Subject: 40 Trinity Place – Notice of Project Change

40 Trinity Place
Boston MA 02116

SECTION KEY

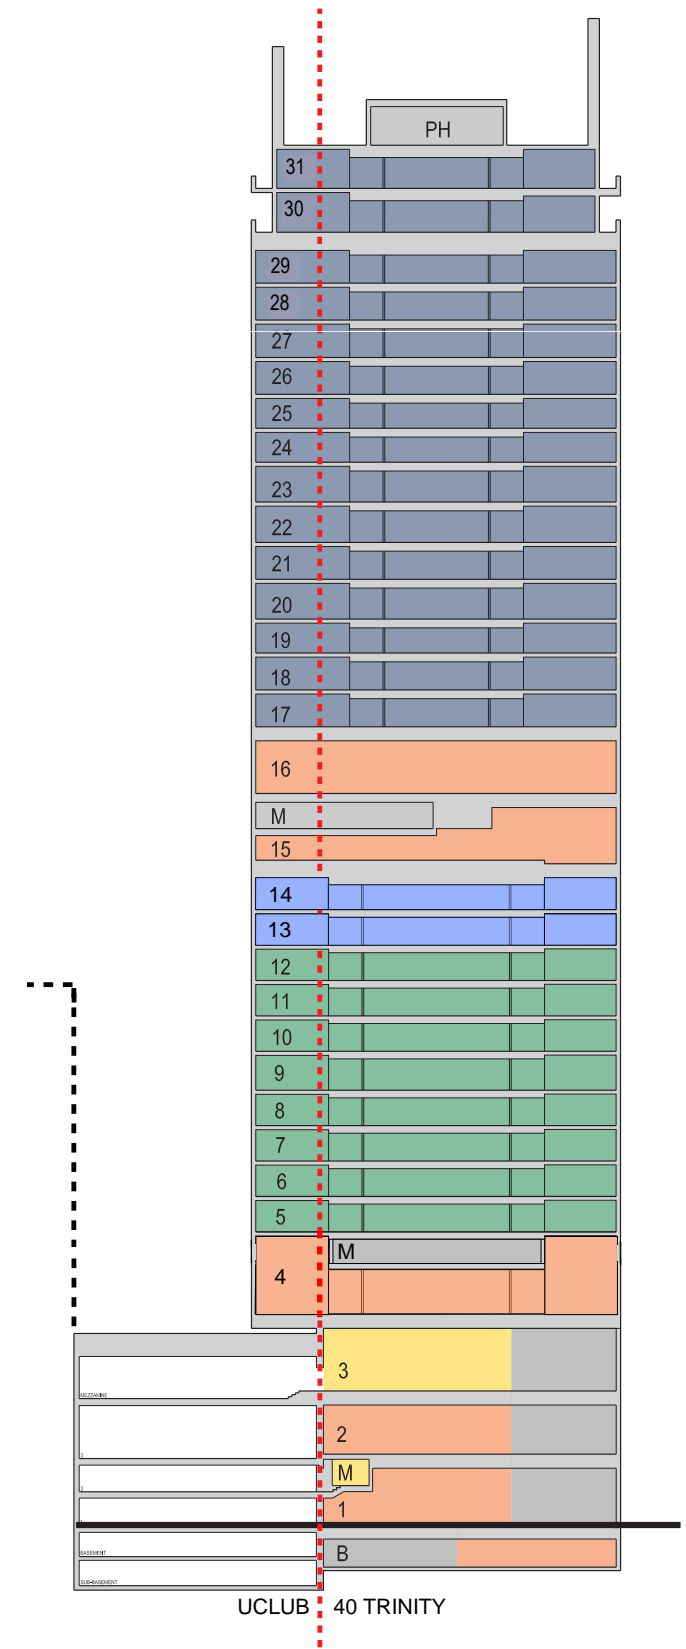
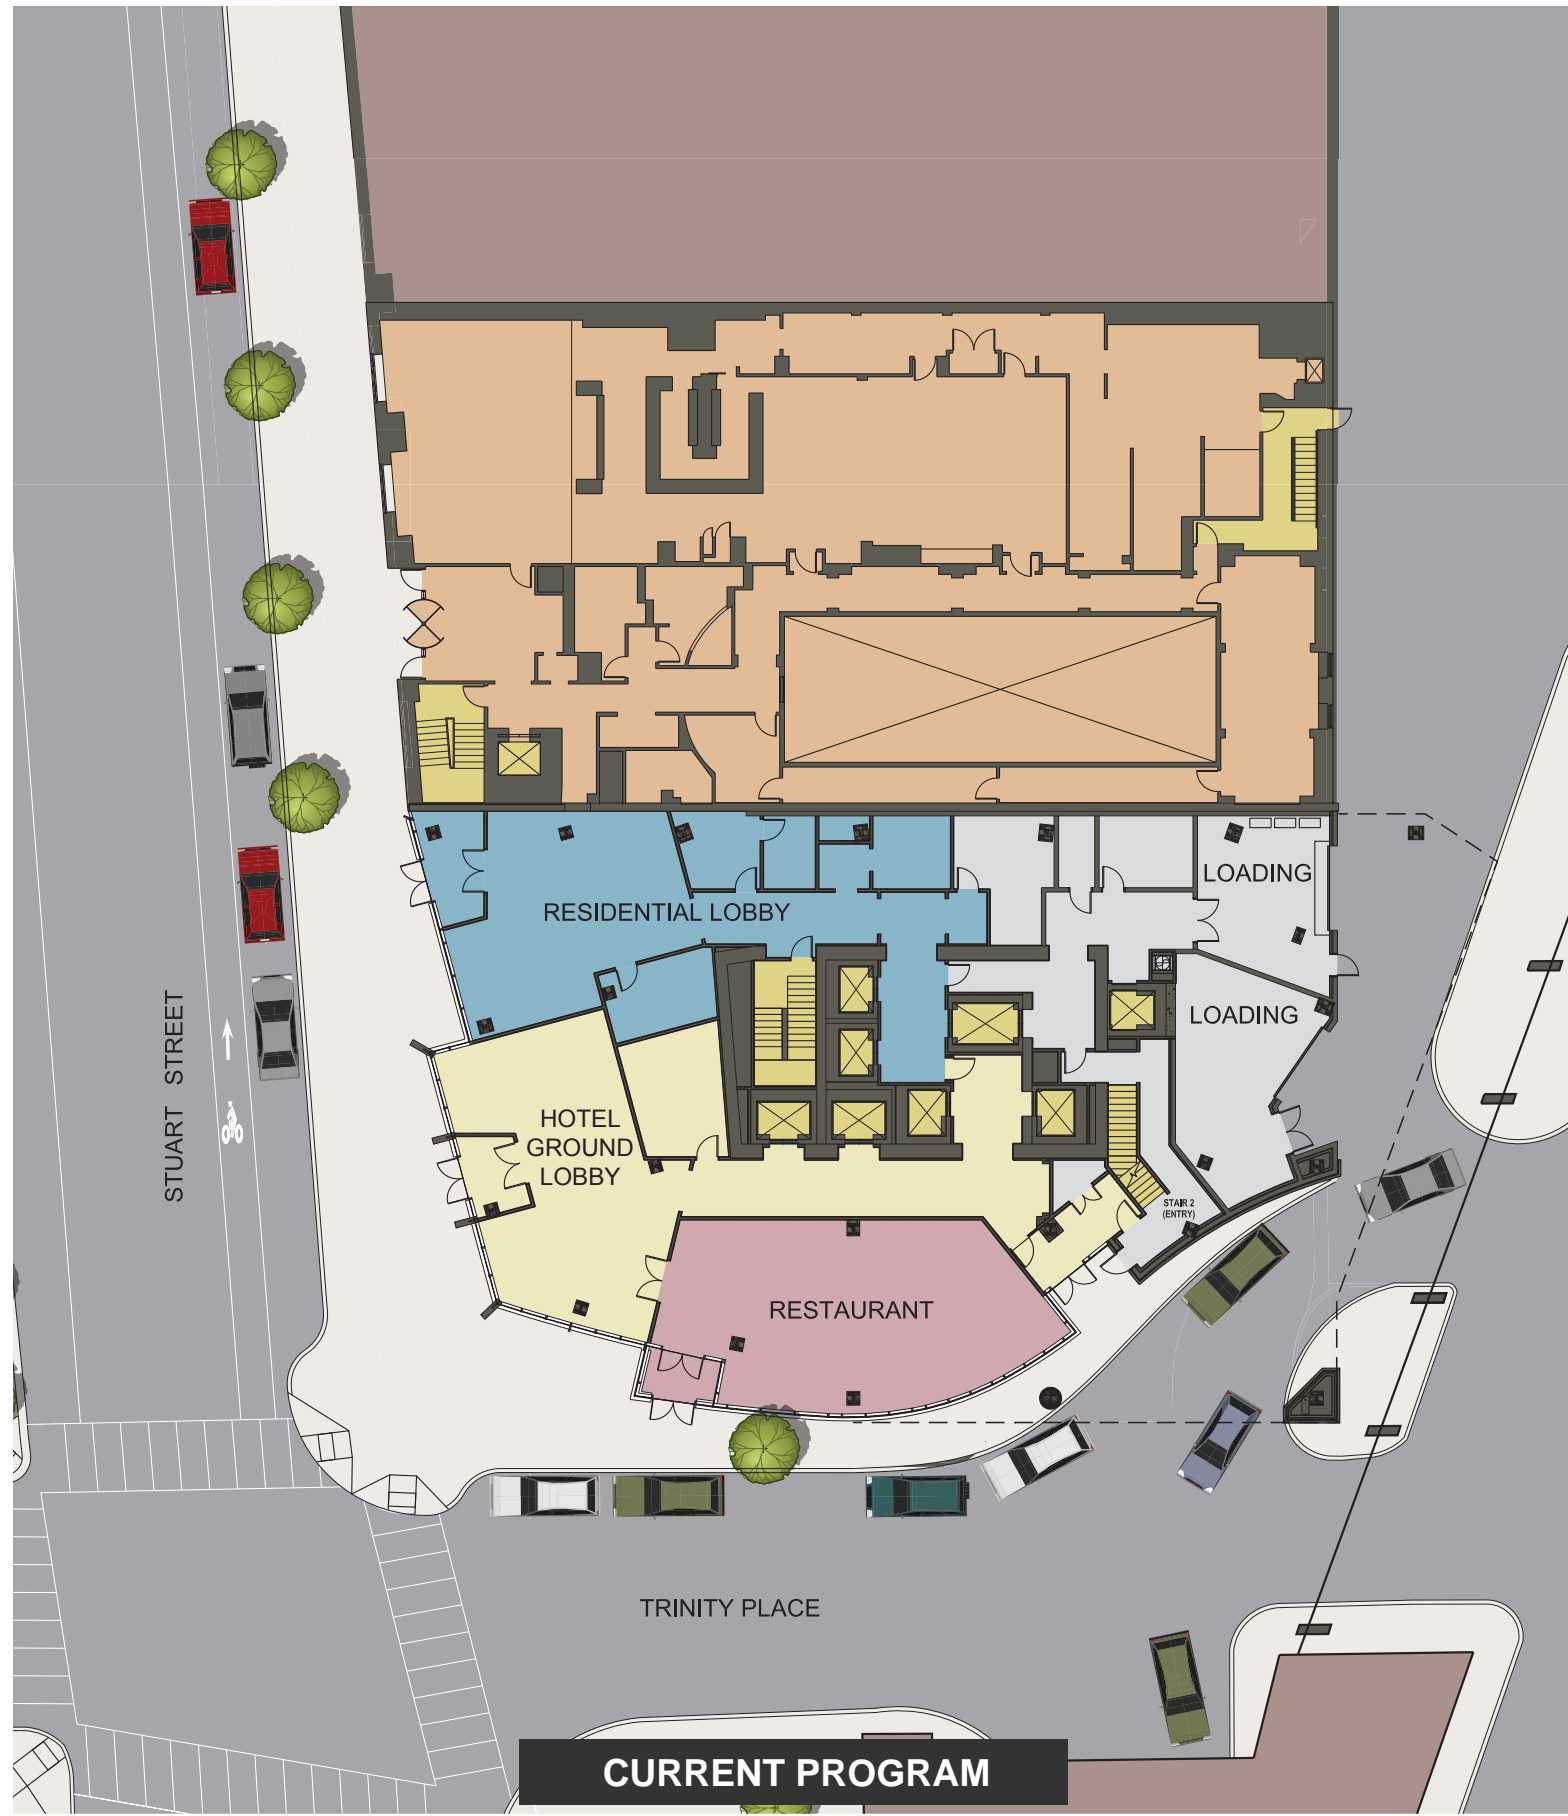
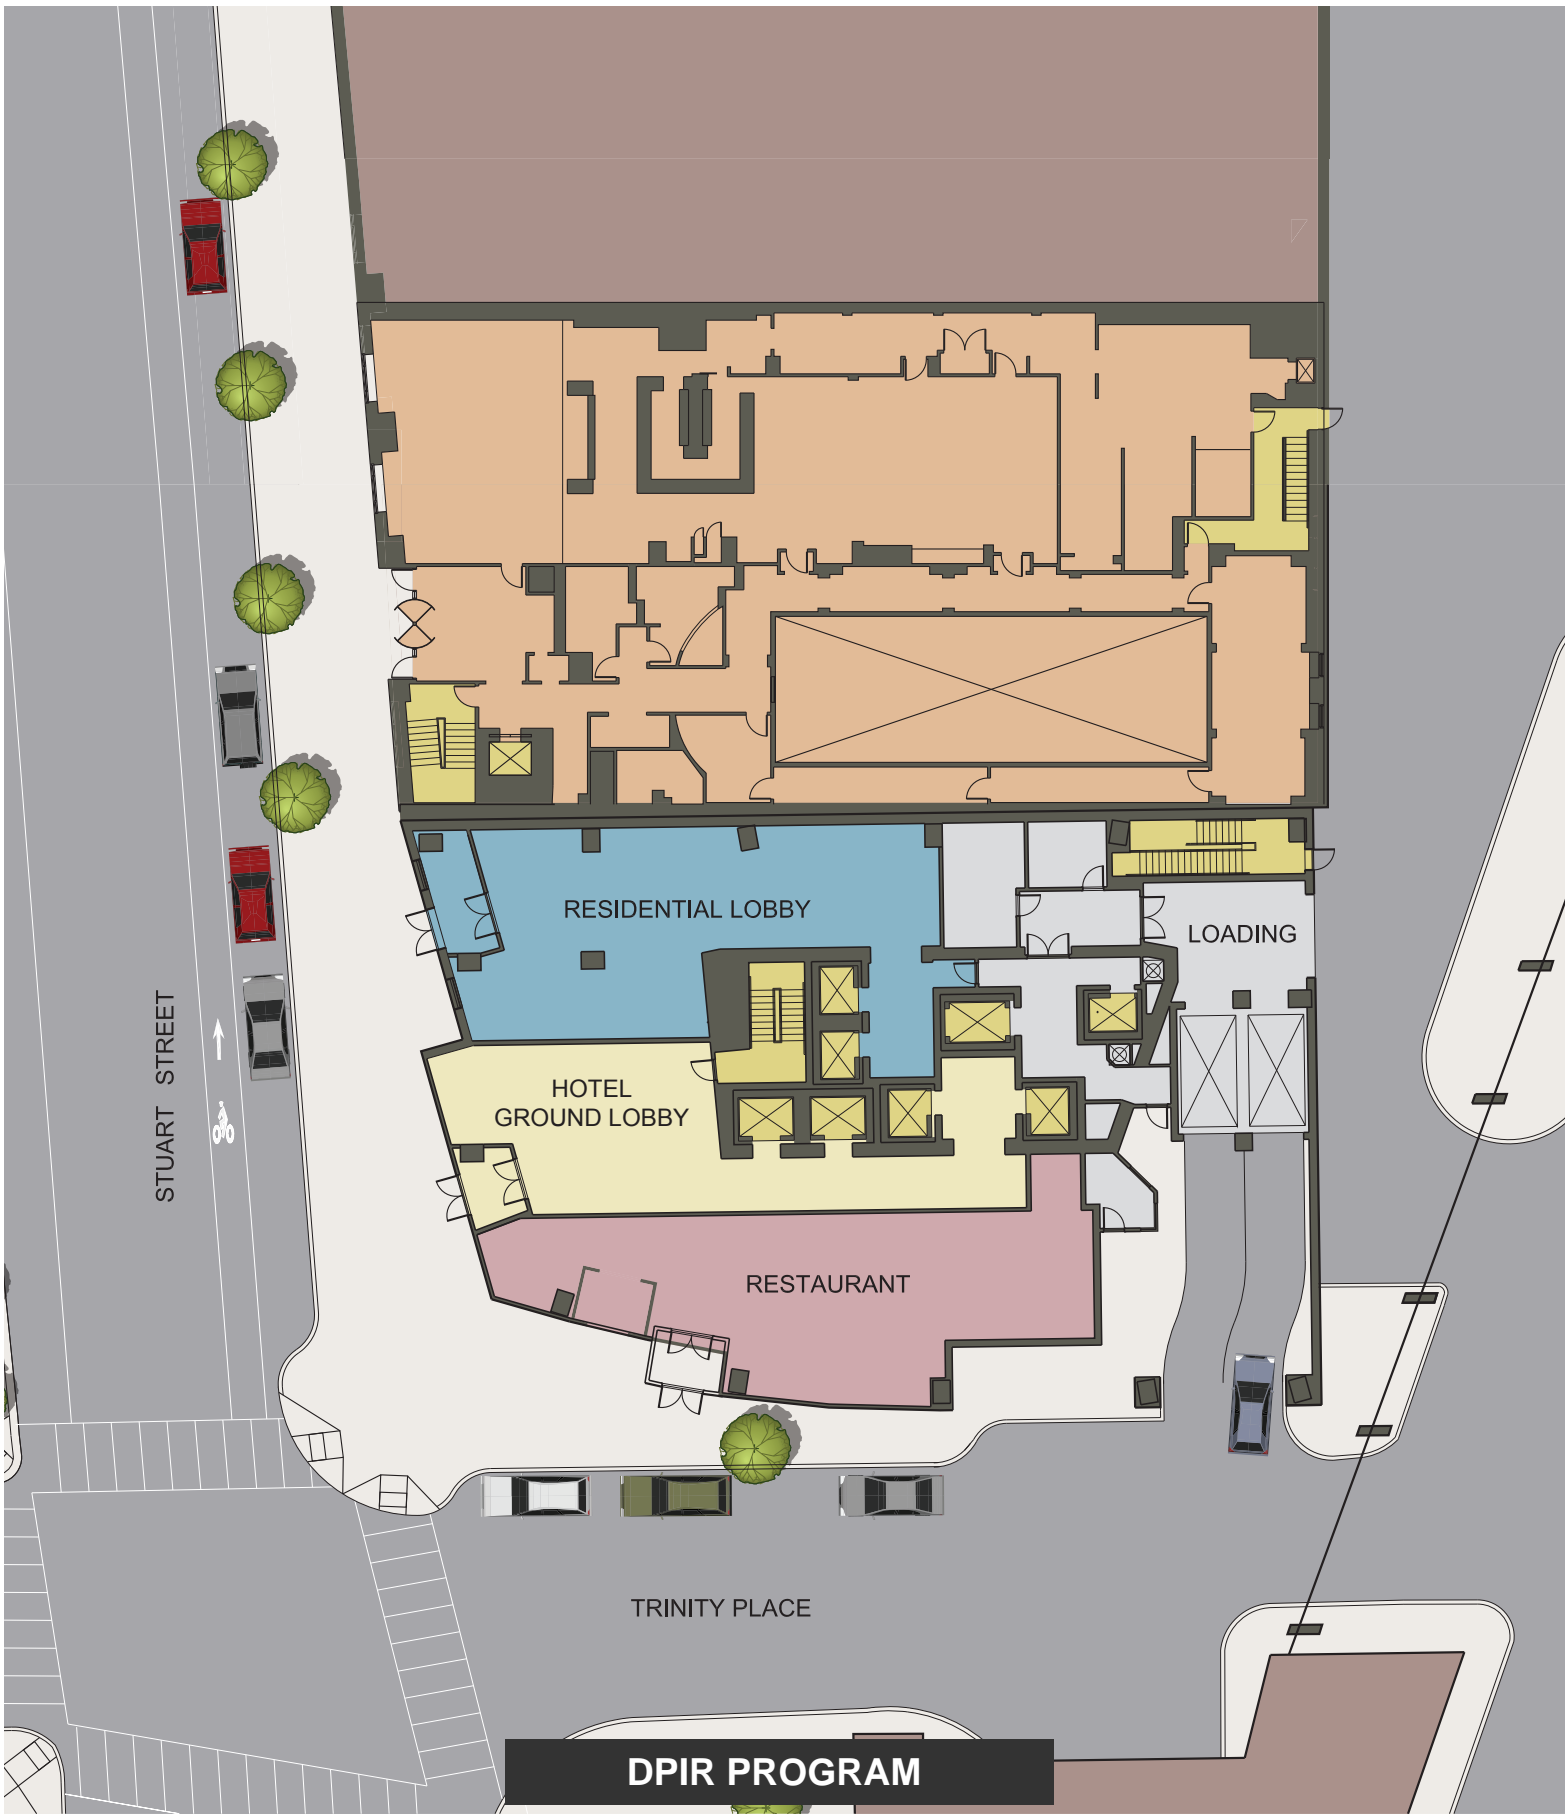
These revisions result in minor changes to the ground floor layout, an improvement in vehicular dropoff and circulation configuration, the reduction in height of the Project by approximately seven feet and two stories, and a slight reduction in the Project's gross floor area. Therefore, the updated Project (the "Updated Project") results in an approximately 393' high building with an FAR of approximately 17.5 (calculated as described in the DPIR) containing hotel uses with approximately 154 guest rooms, conference and ballroom areas, and a pool and fitness center, approximately 146 modern condominium units, three restaurants and lounges totaling approximately 11,300 square feet and expansion space for the adjacent University Club.

The attached exhibits depict the building section, ground floor and renderings of the Approved Project and the Updated Project. These exhibits are illustrative and subject to refinement as part of the typical design process.
